**Response to
Request for Additional Information No. 6, Revision 0
6/05/2008**

U. S. EPR Standard Design Certification

AREVA NP Inc.

Docket No. 52-020

Figure 19-81-1—Containment Event Tree Supporting Fault Trees (Sheet 1 of 19)

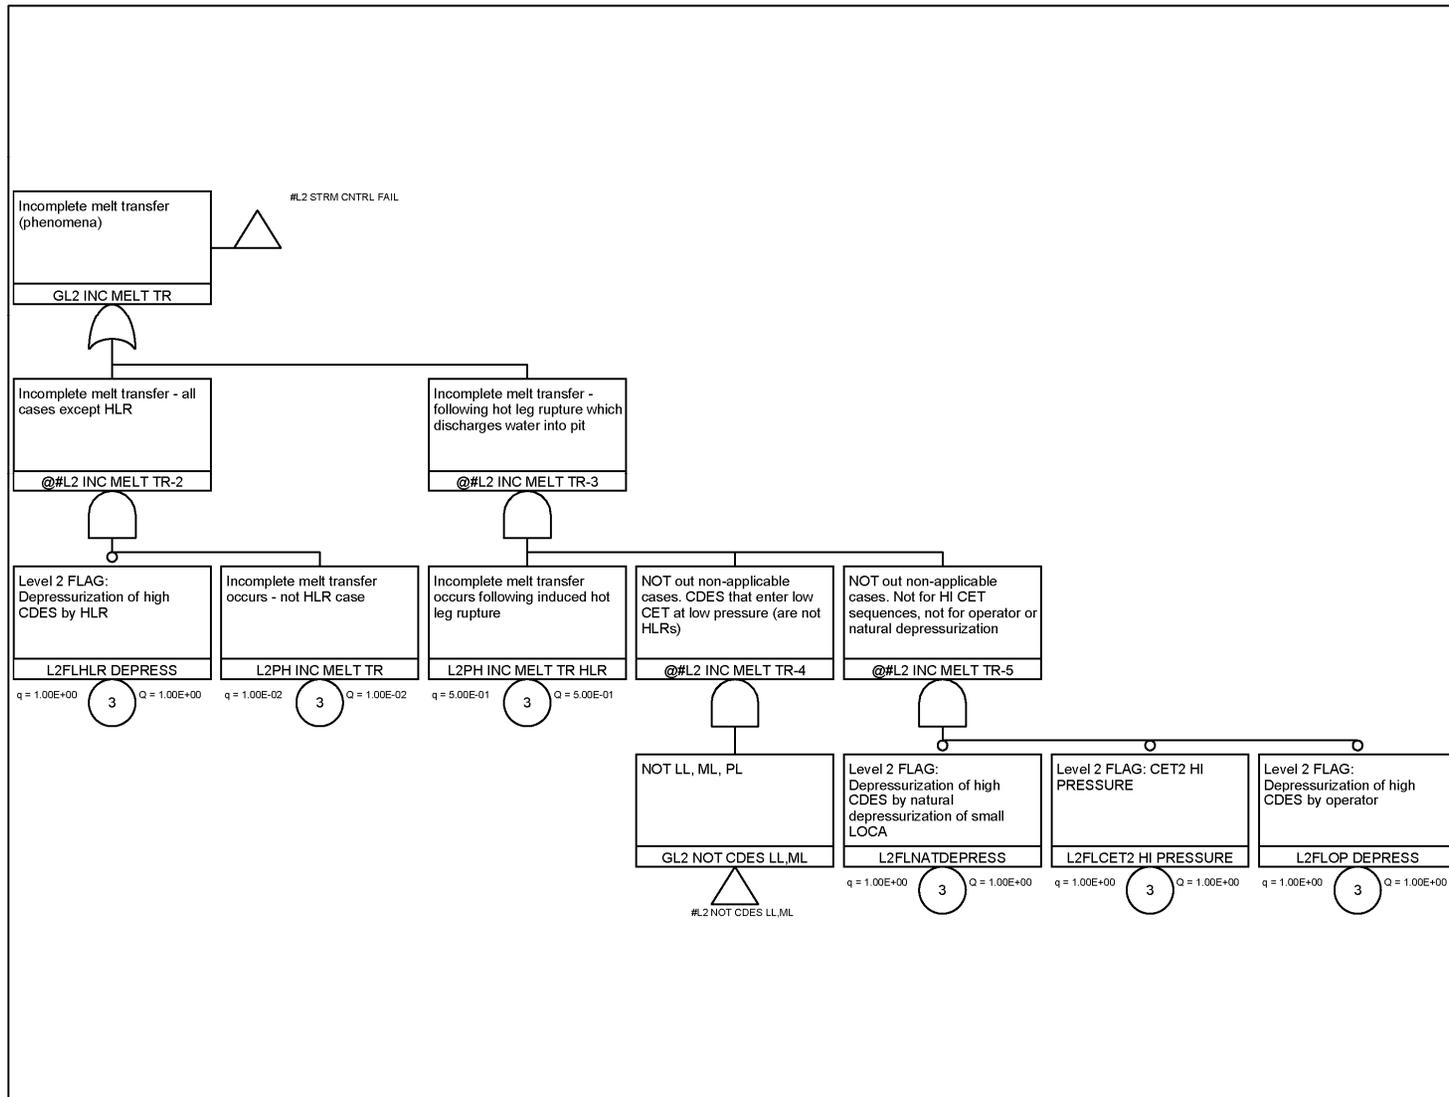
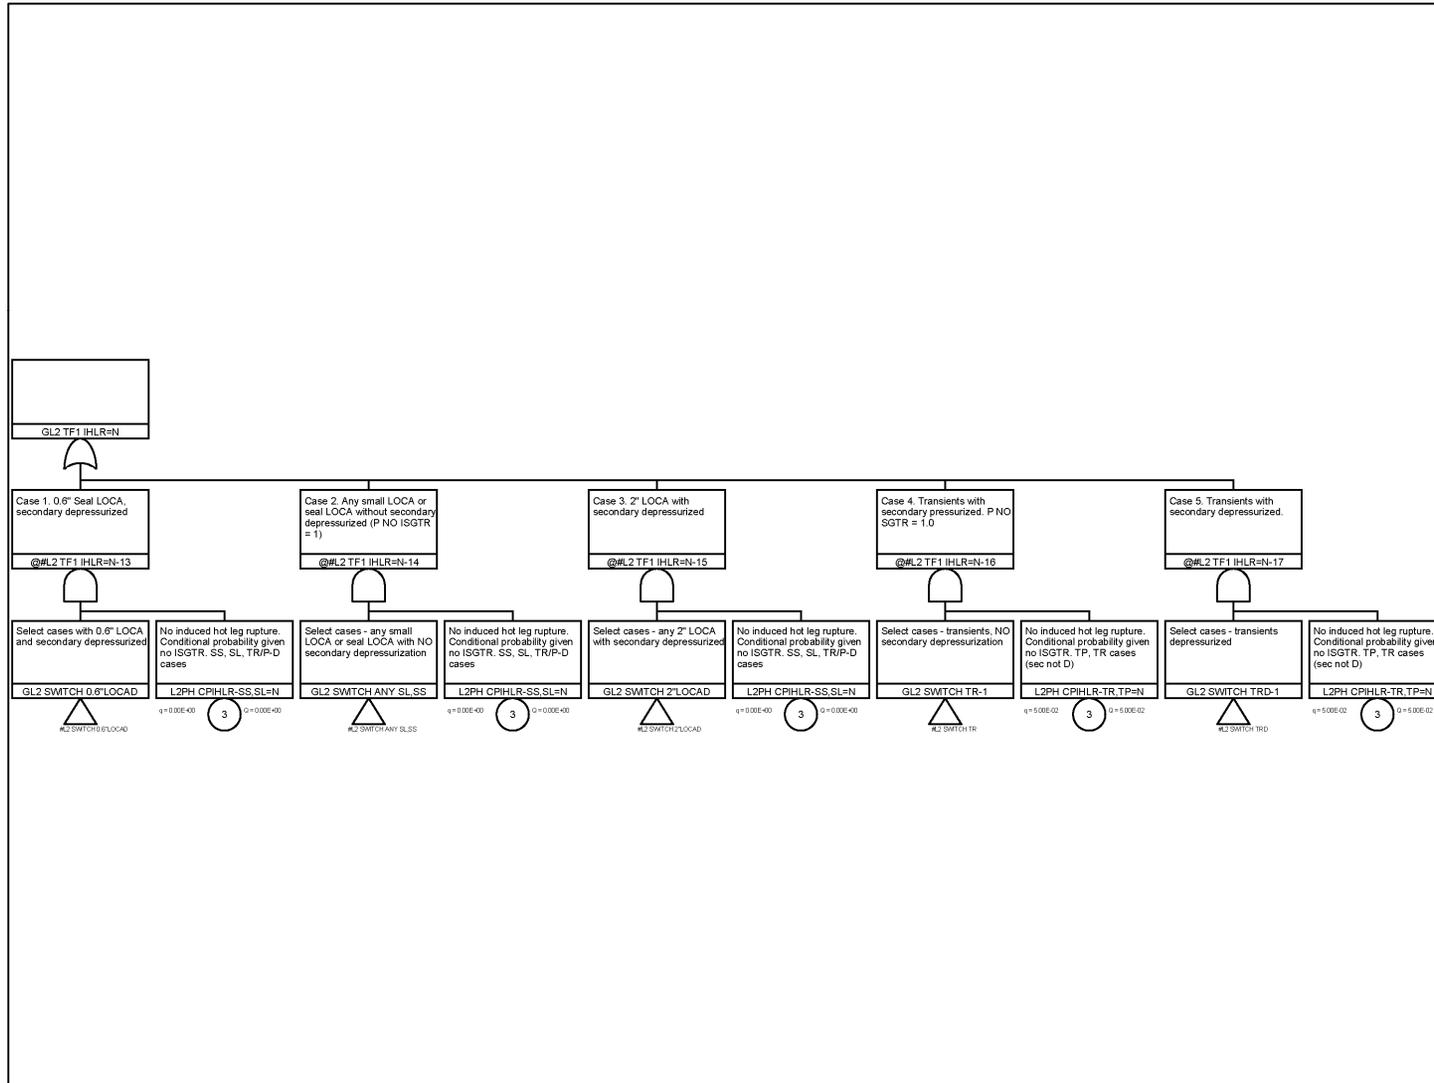
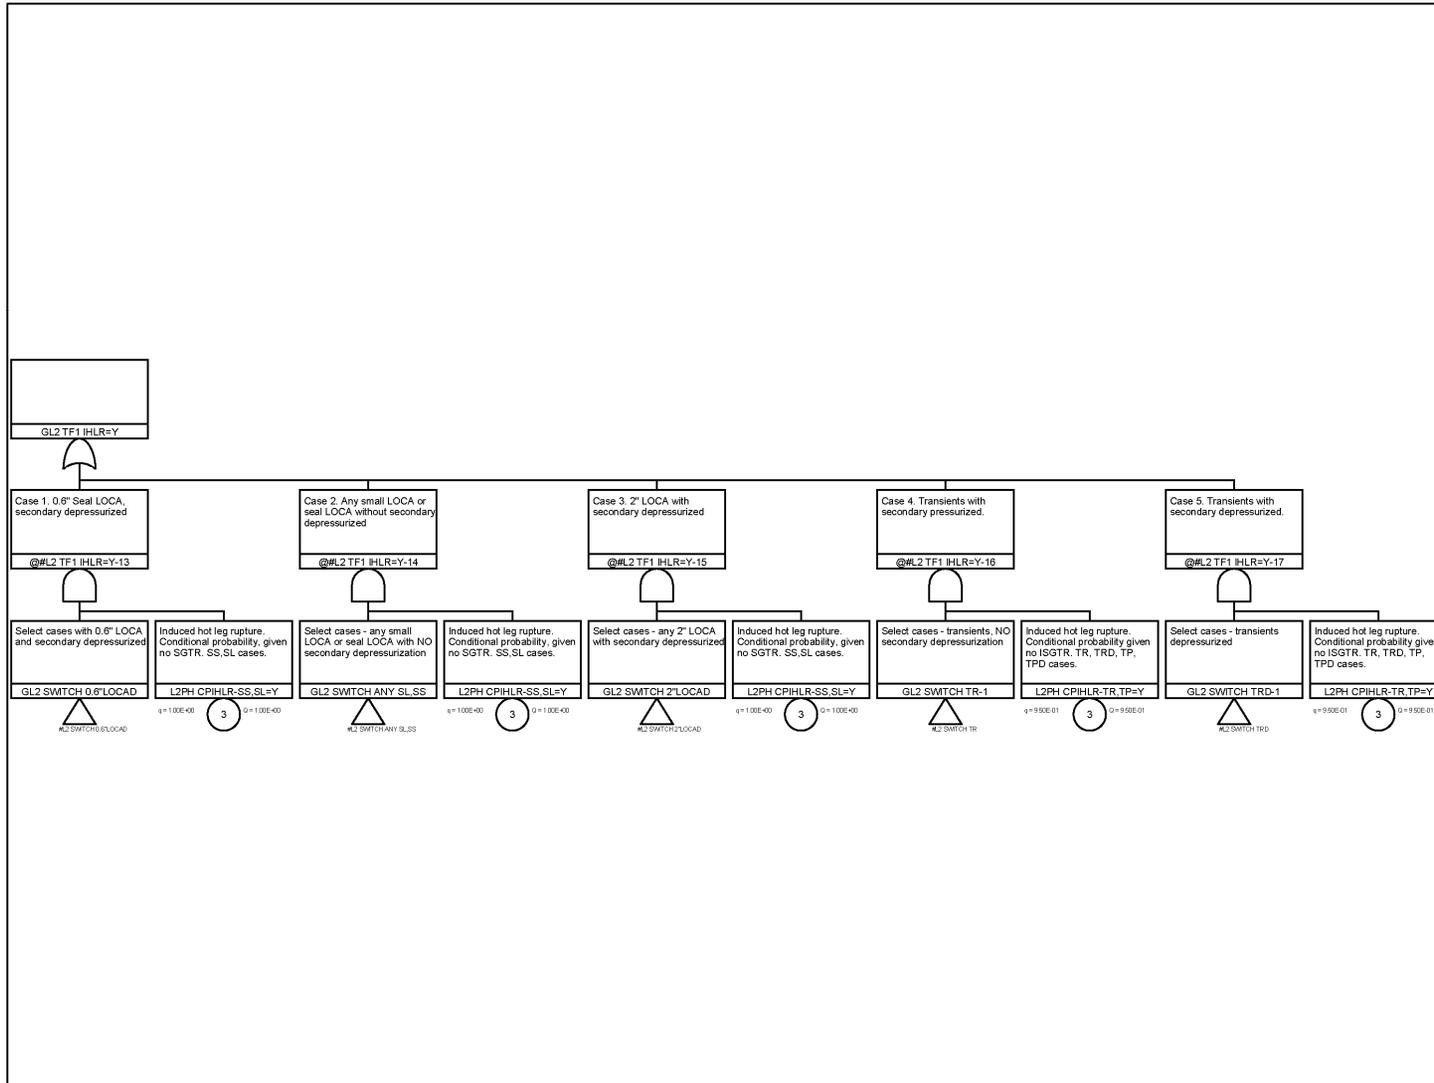
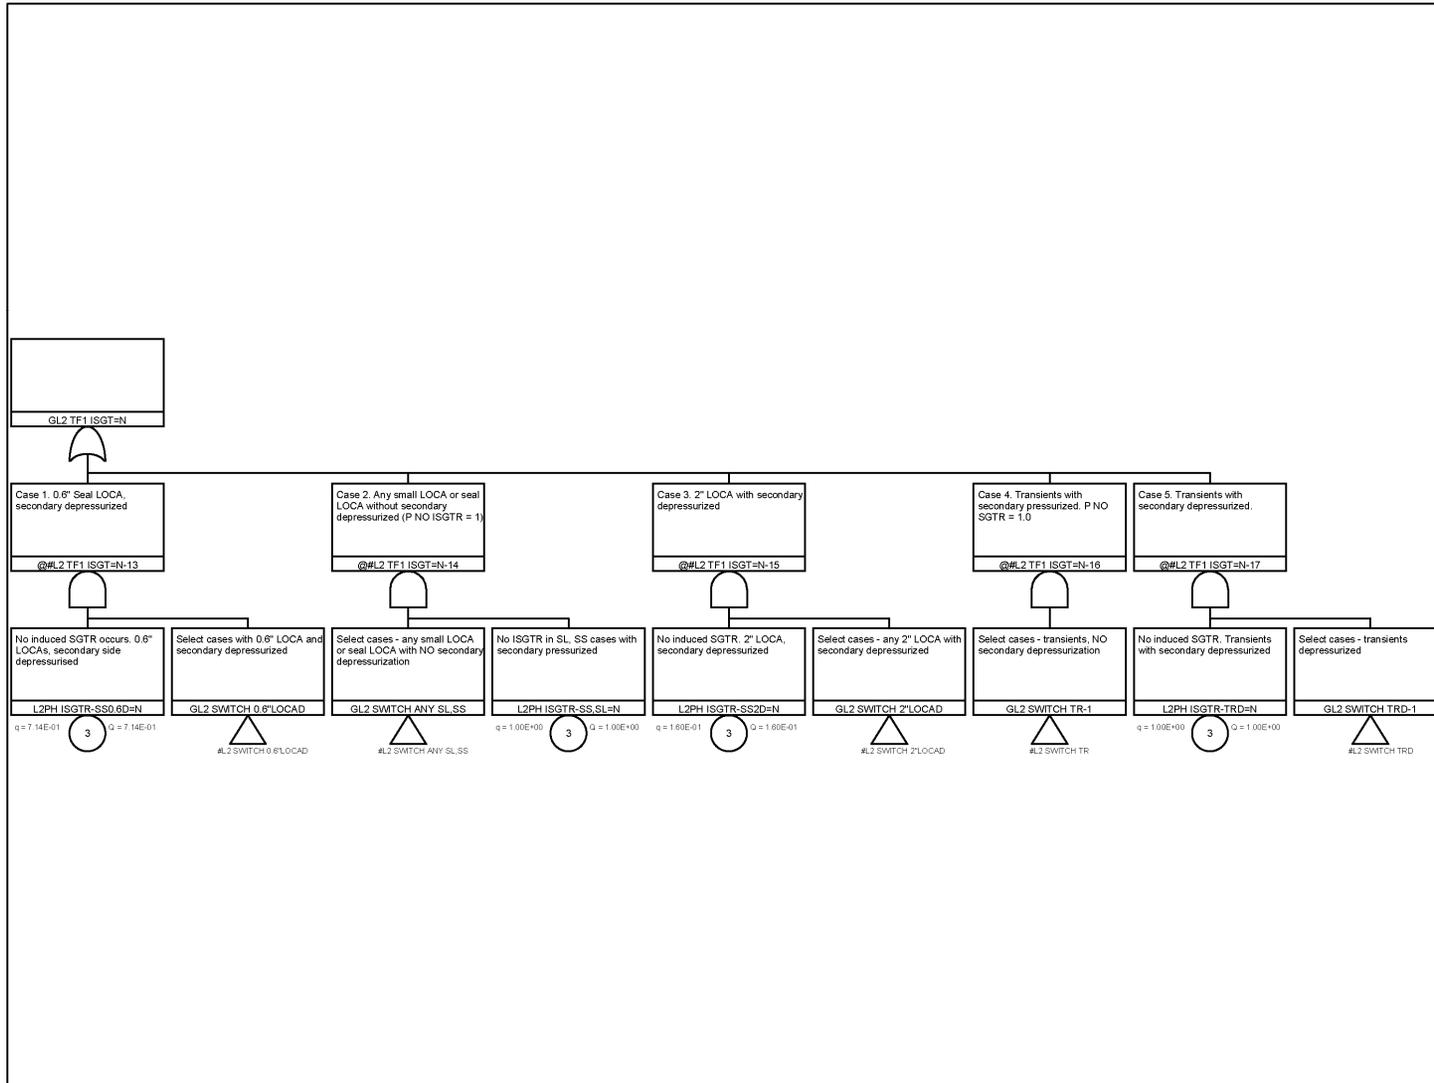
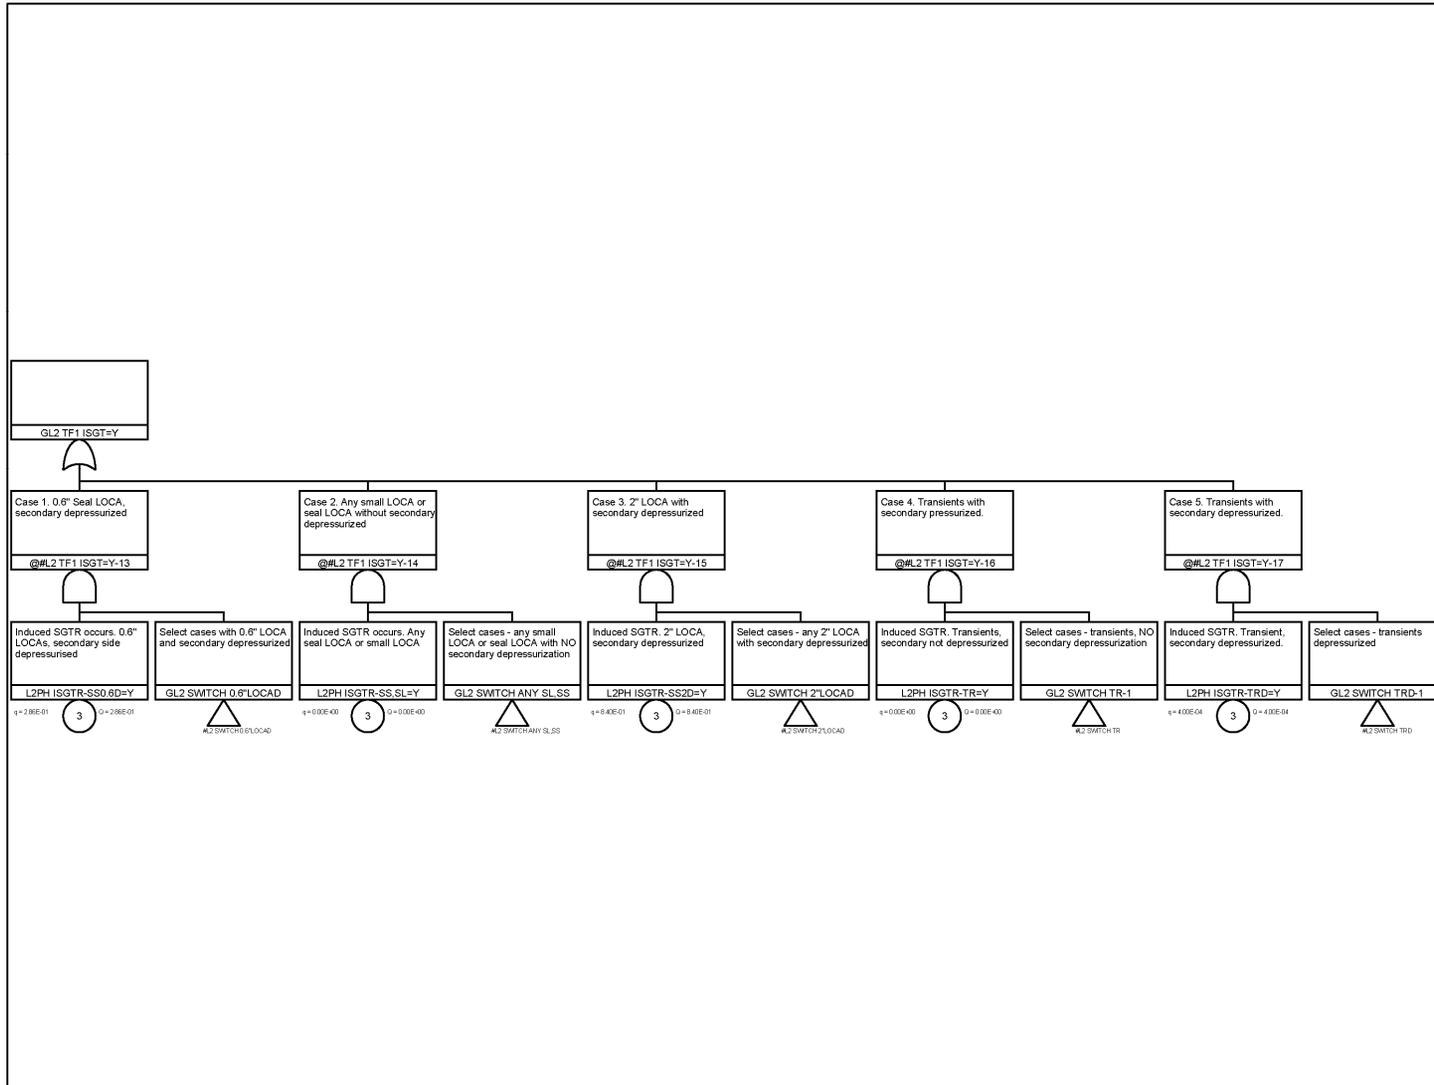
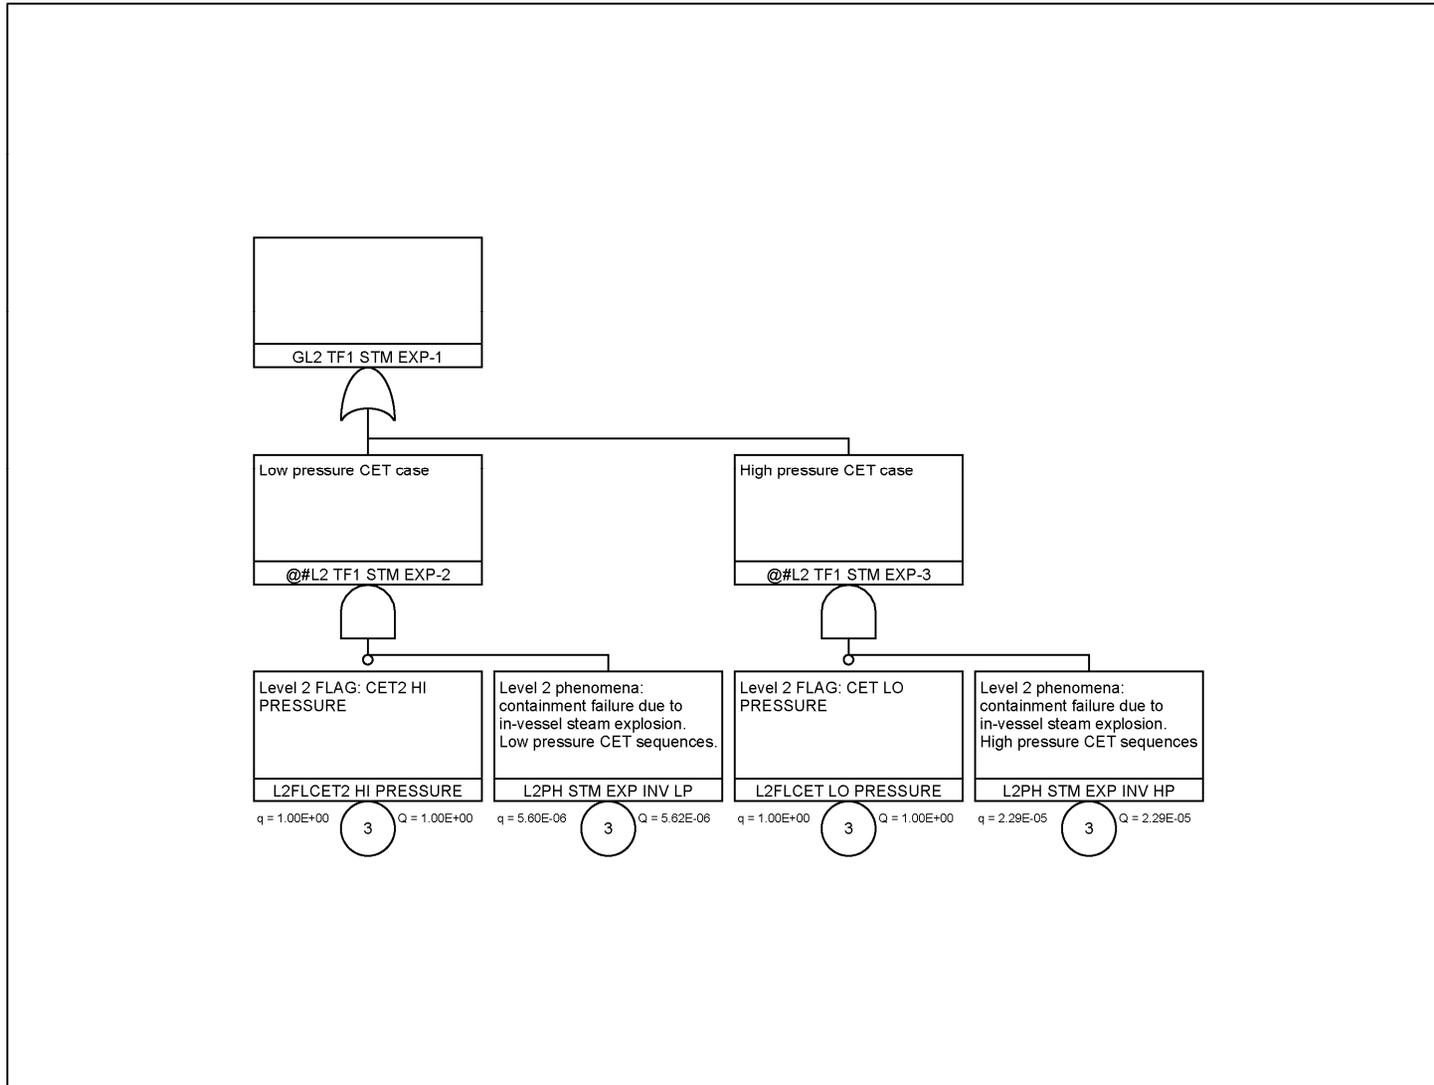
For the Level 2 phenomenological basic events (i.e., those events with identifiers "L2PH..."), please supply the associated discrete uncertainty probability distributions and the supporting bases for these values. Also supply the CET-supporting fault trees that utilize these events. Examples of such basic events would be MCC1 probabilities in various circumstances, containment overpressure failure probability during debris quench, in-vessel and ex-vessel steam explosion consequences, and "rocket" mode RPV failure. In addition, please provide the numerical values for any other branch probabilities of events in the containment event trees documented in Appendix 19C of the FSAR that are not covered by the above request.

The CET-supporting fault trees that utilize these phenomenological events are shown in Figure 19-81-1 Sheets 1 thru 19.

Figure 19-83-1—Source Term Grouping Diagram

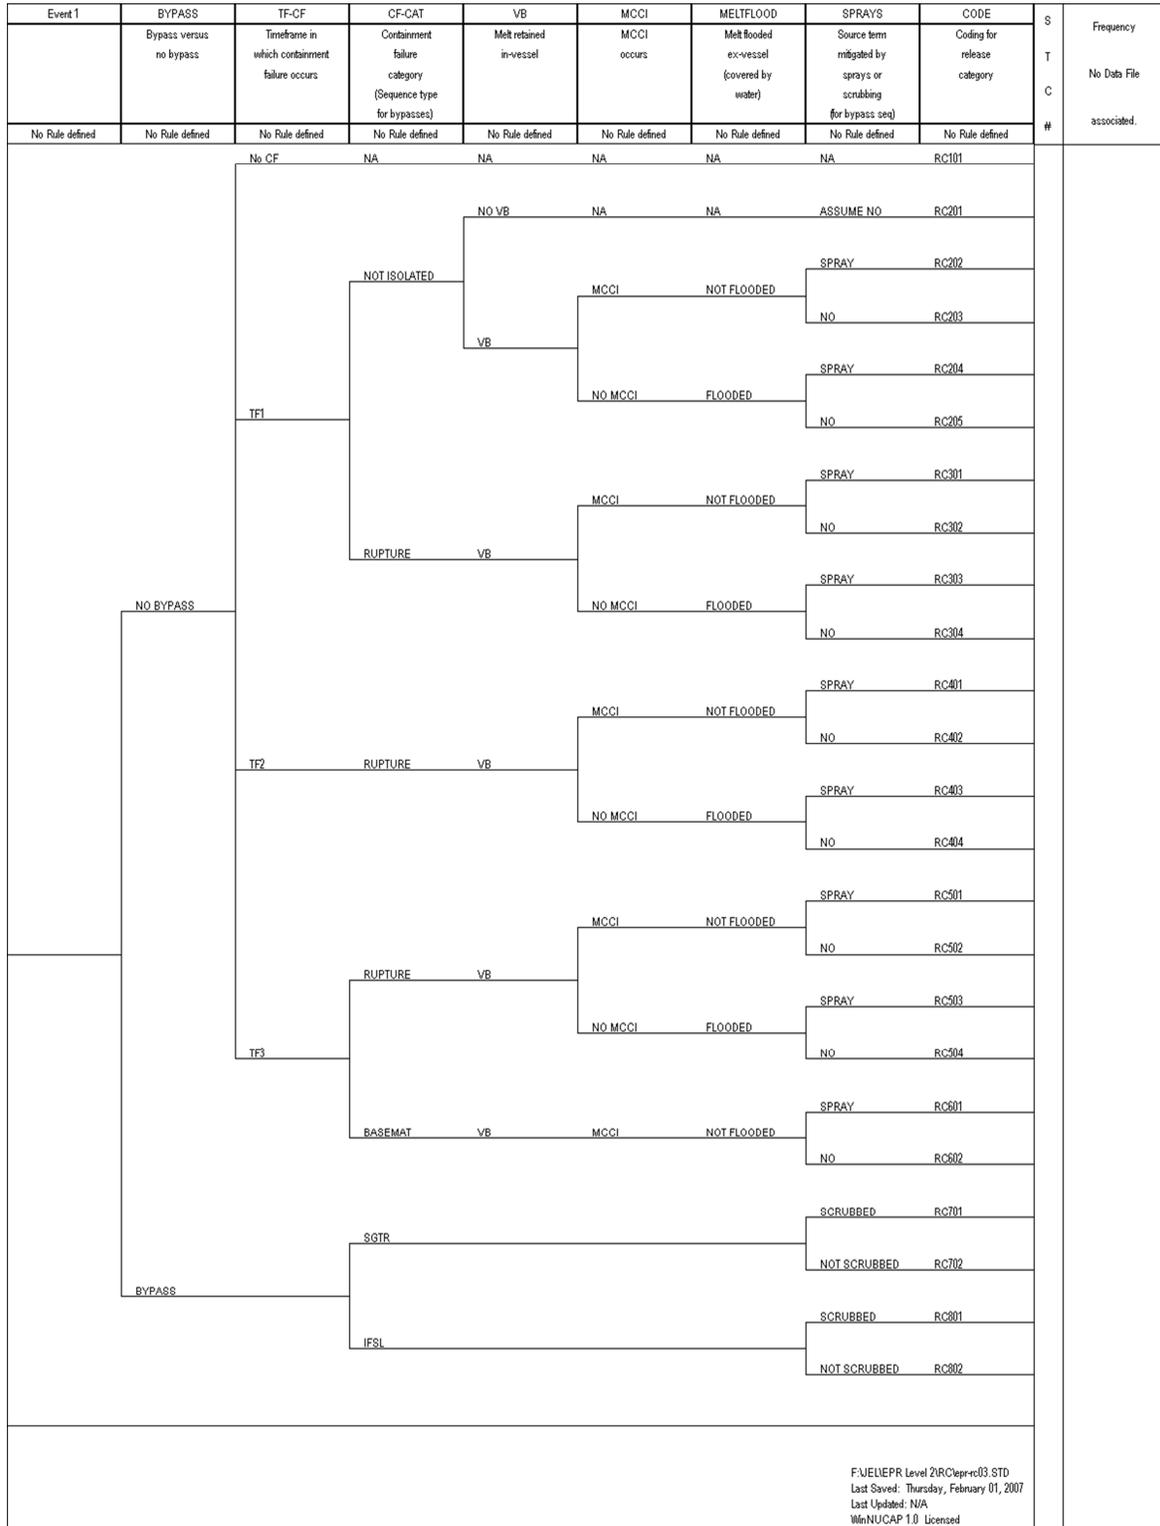
Please provide a source term grouping diagram that includes the various attributes of the accident sequences that have been considered in defining and describing the release categories. In addition, please provide a mapping of sequences simulated by MAAP 4.0.7 runs to the release categories.

Figure 19-83-1 provides the source term grouping diagram that includes the various attributes of the accident sequences that have been considered in defining and describing the release categories.
